Riverfront Phase IIB Fort Wayne, IN

ADDENDUM #1

October 7, 2024

ADDENDUM NO. 1

END OF SECTION

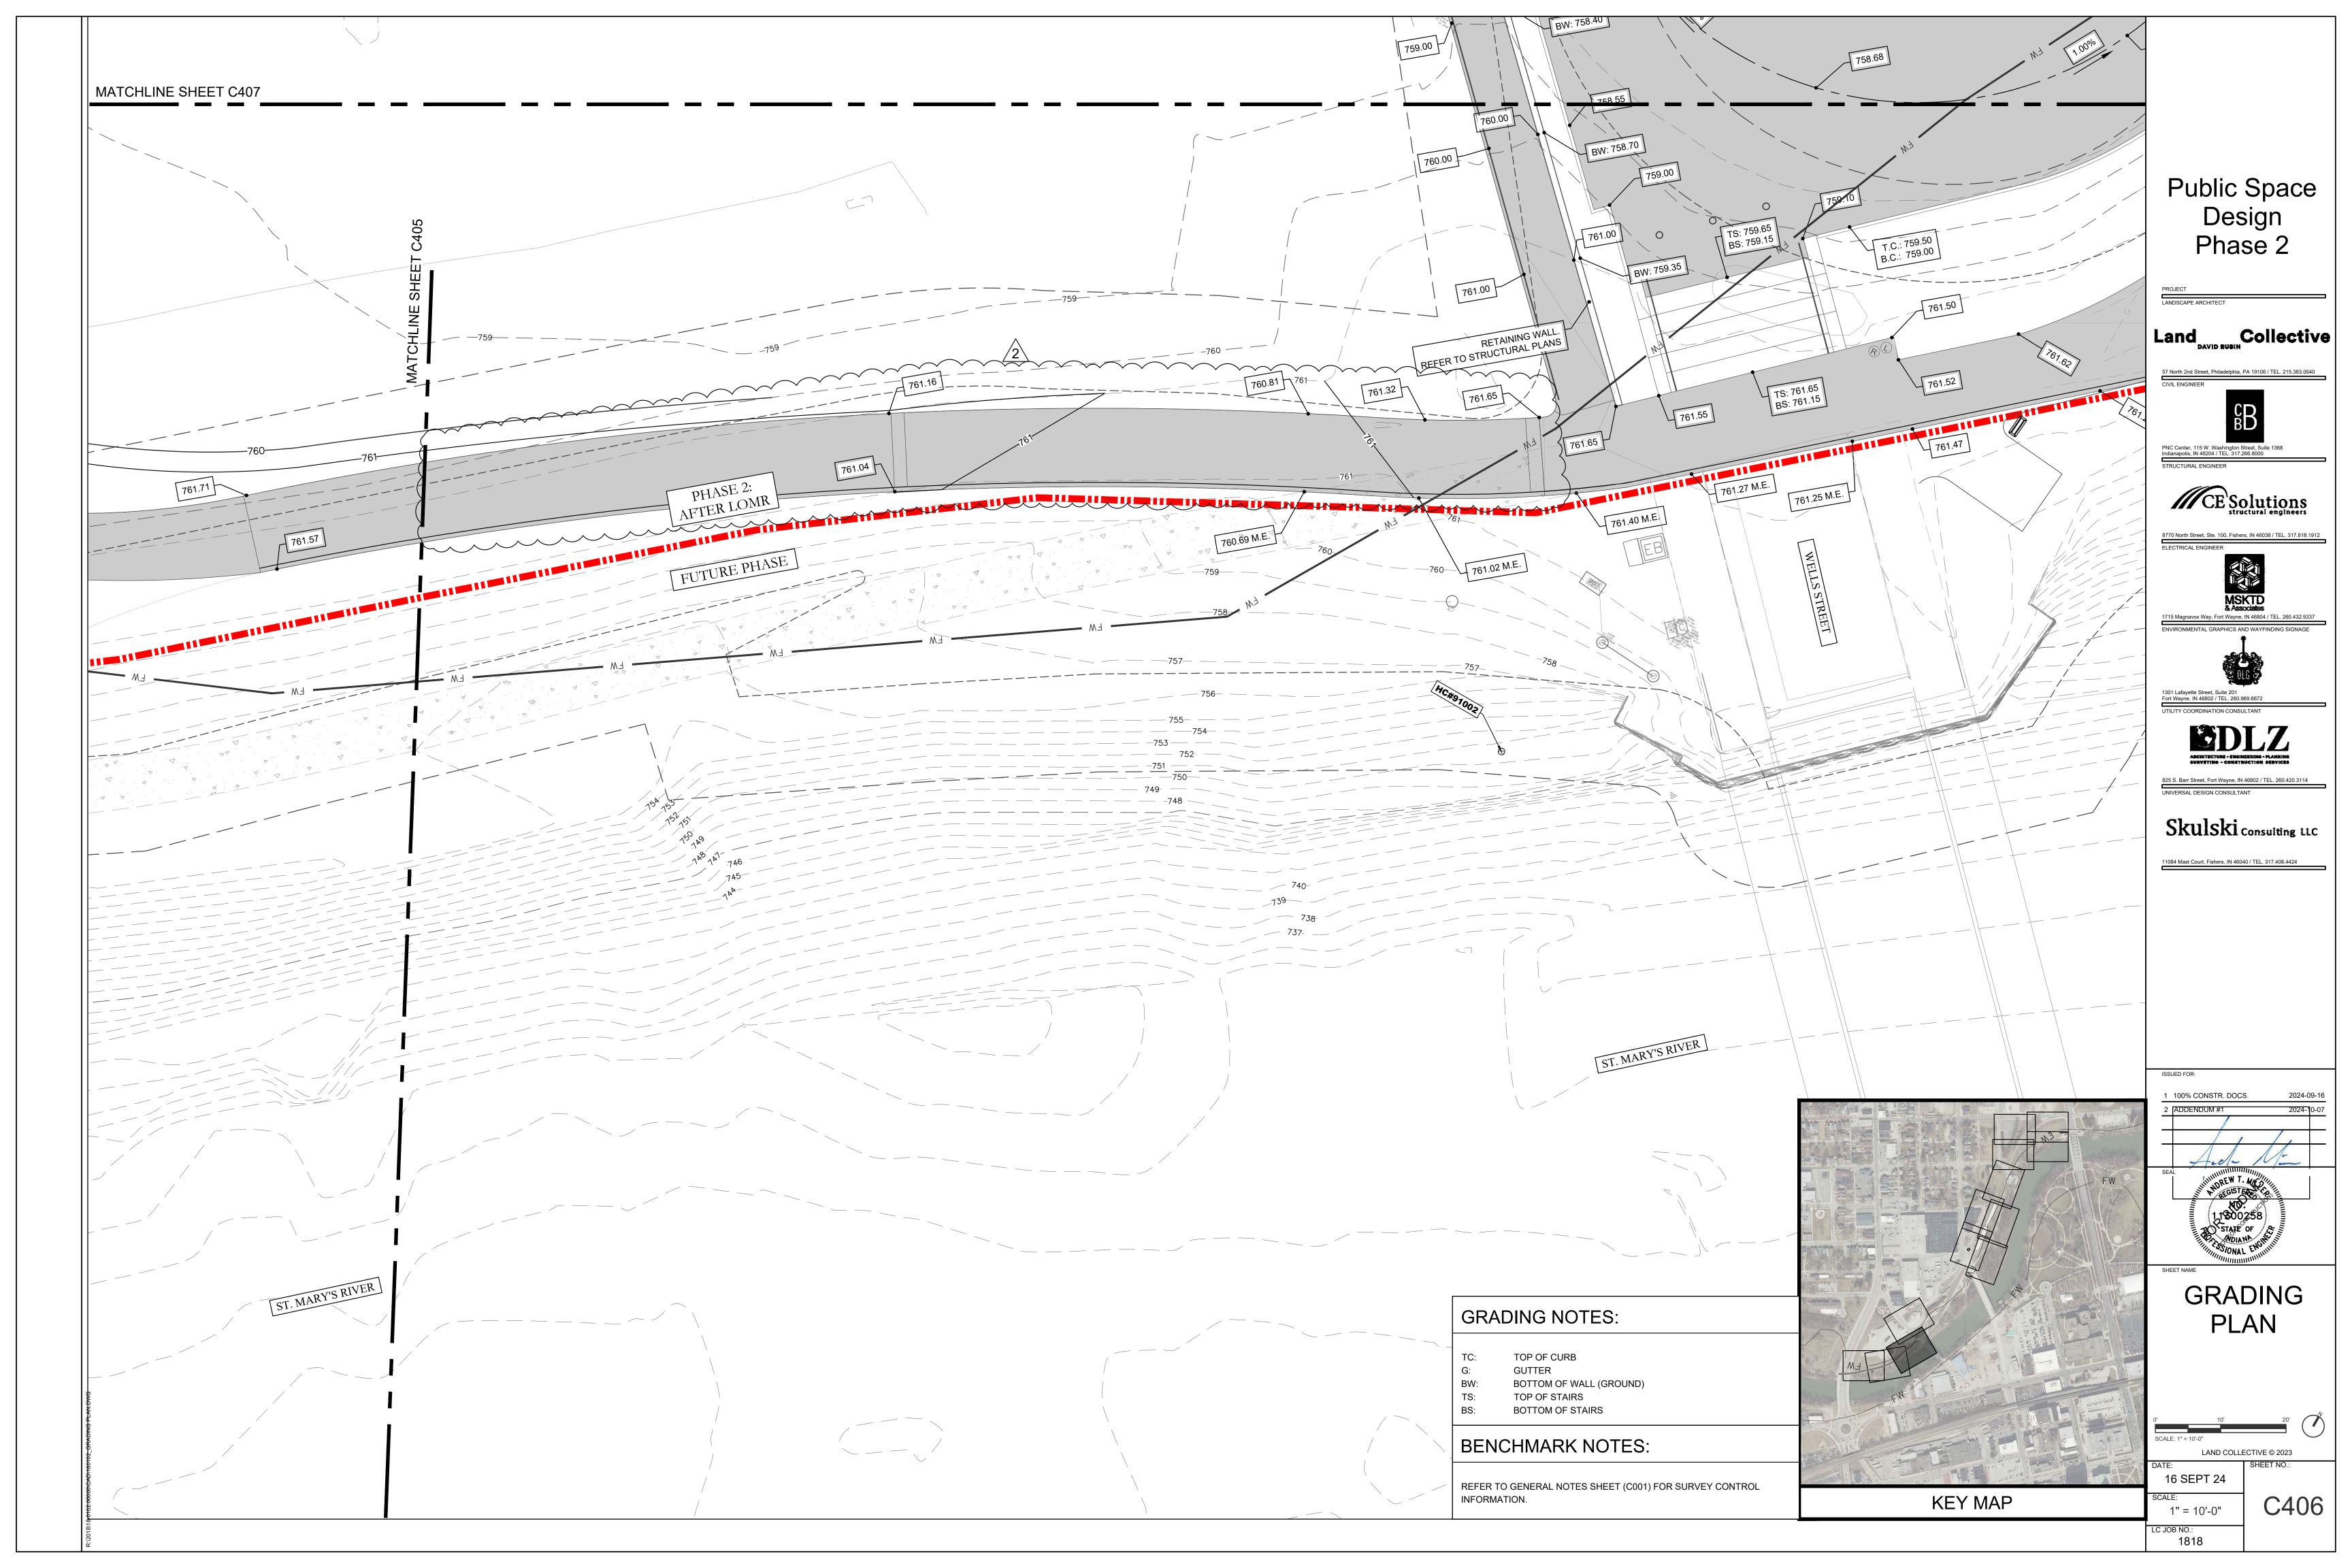
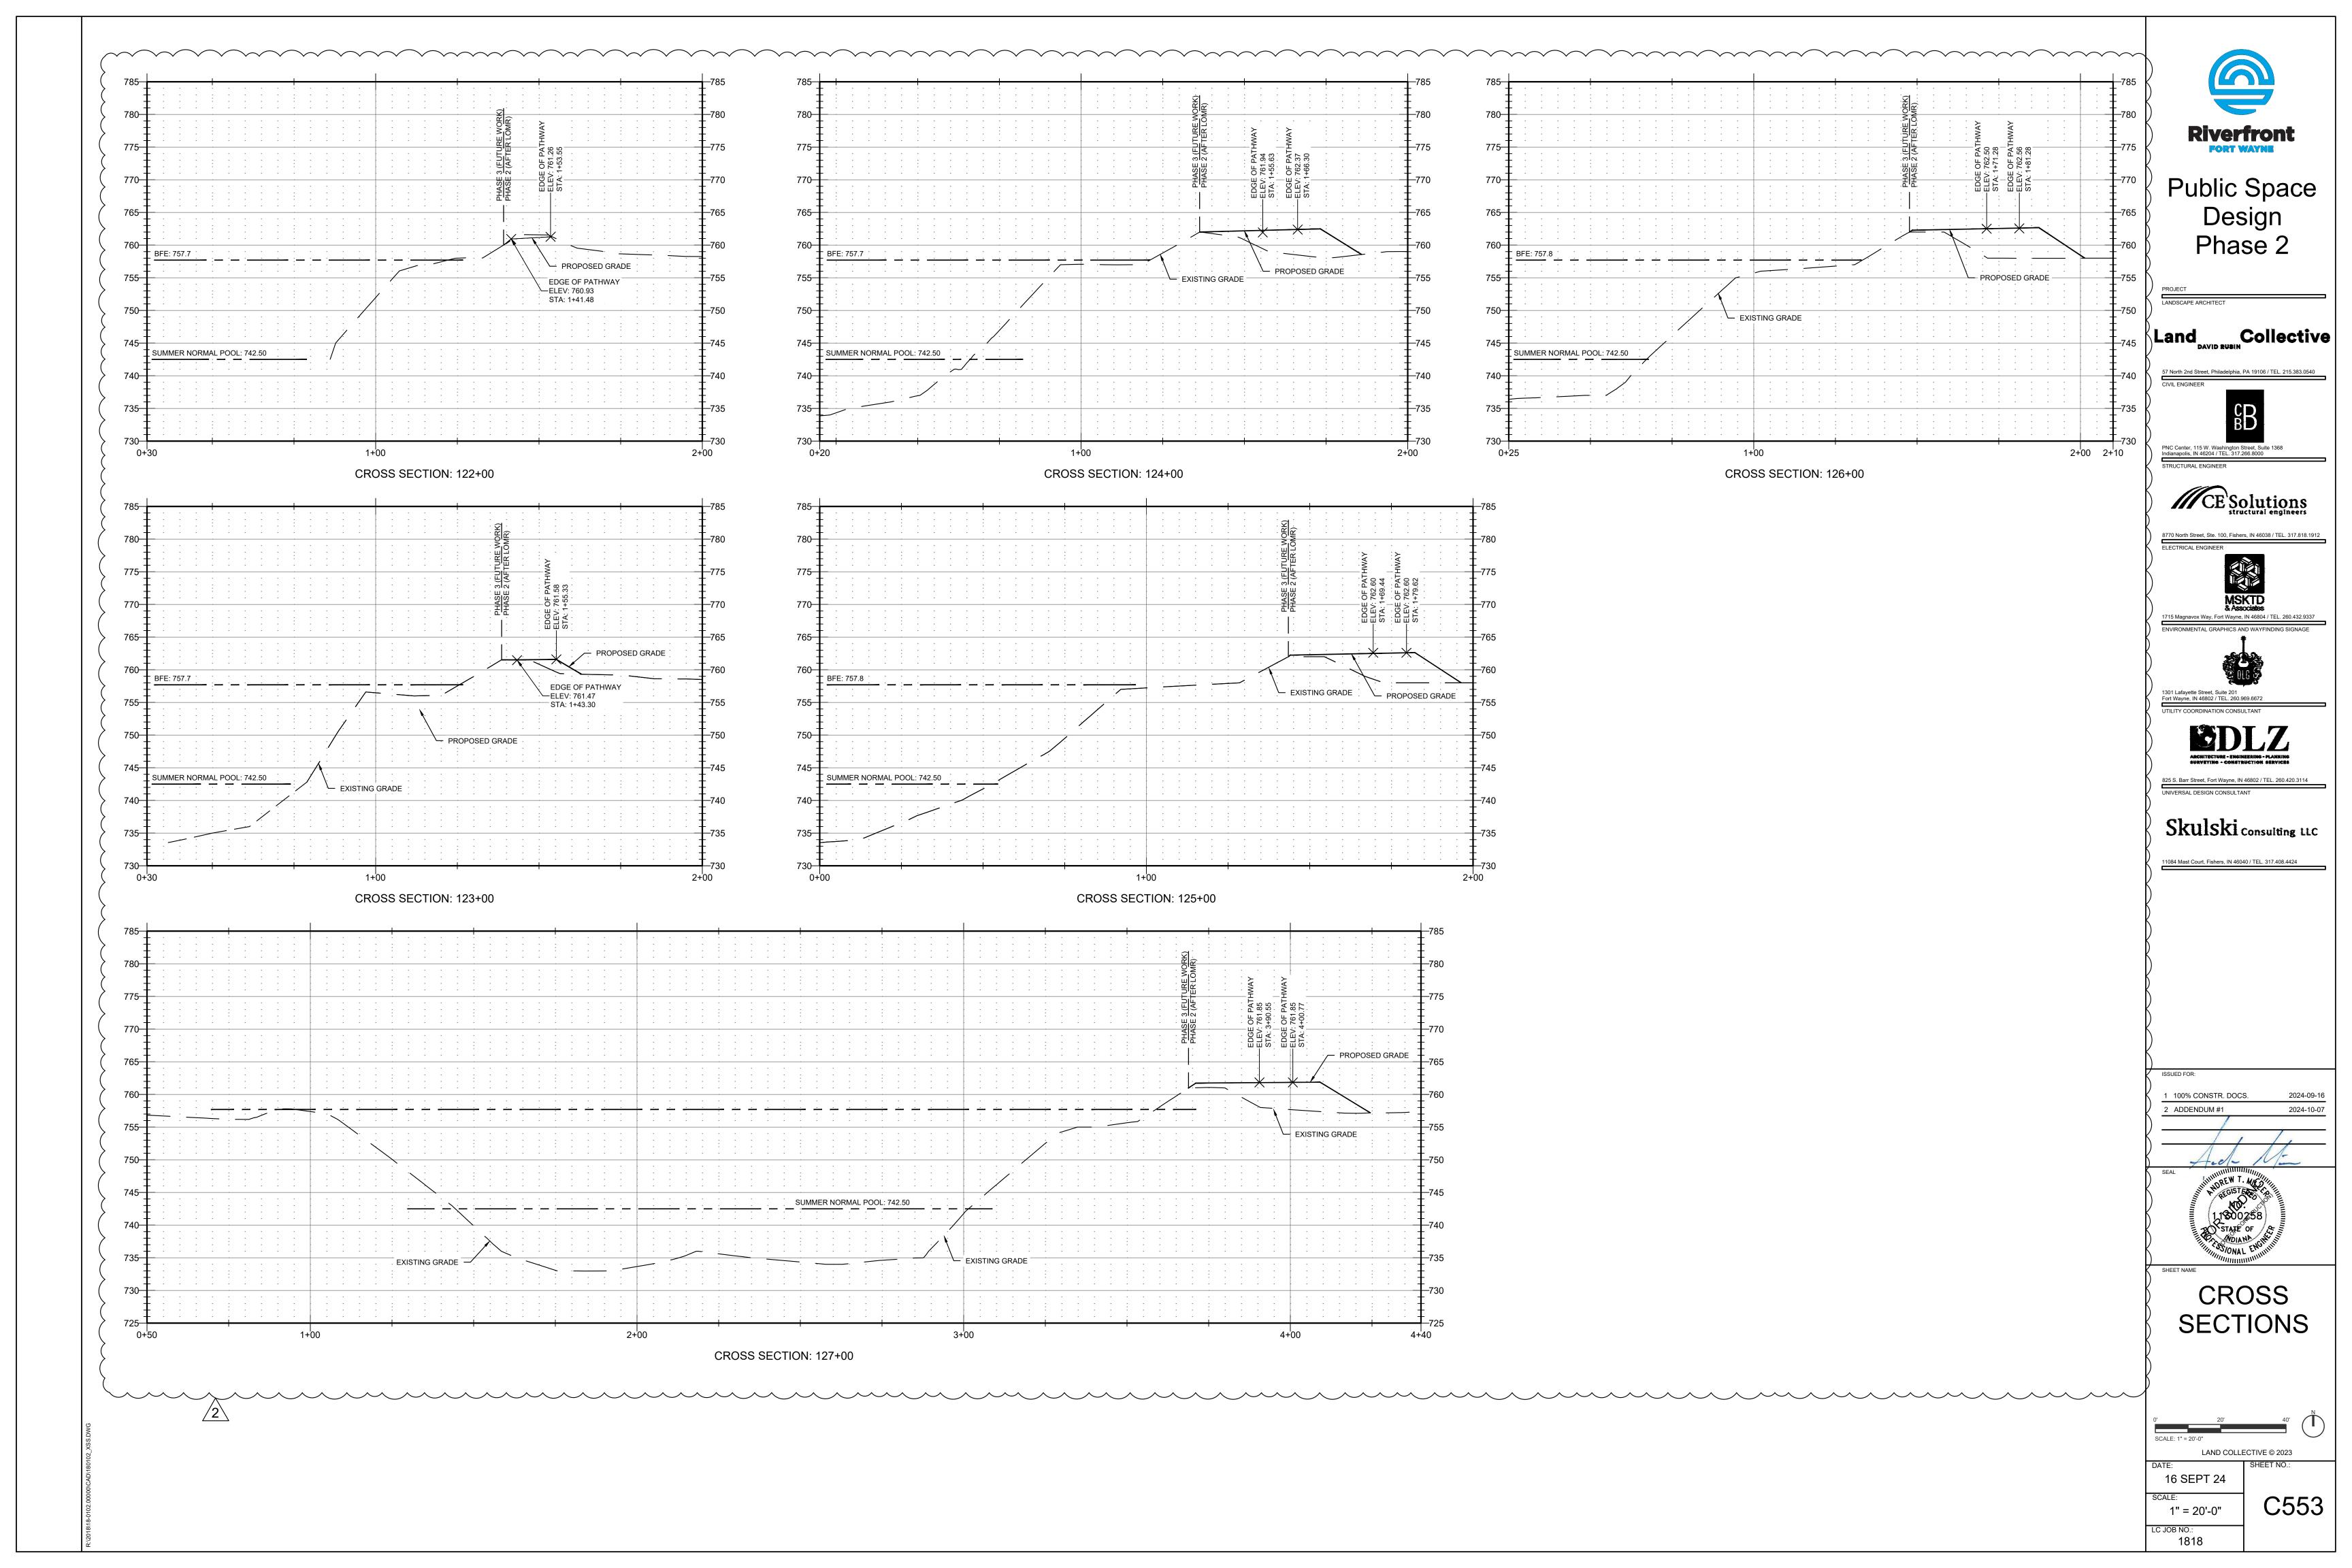
C606 - Miscellaneous Details

- Added Detail #2 Removable Bollard
- Added Detail #3 Trail Connection at Ewing Street
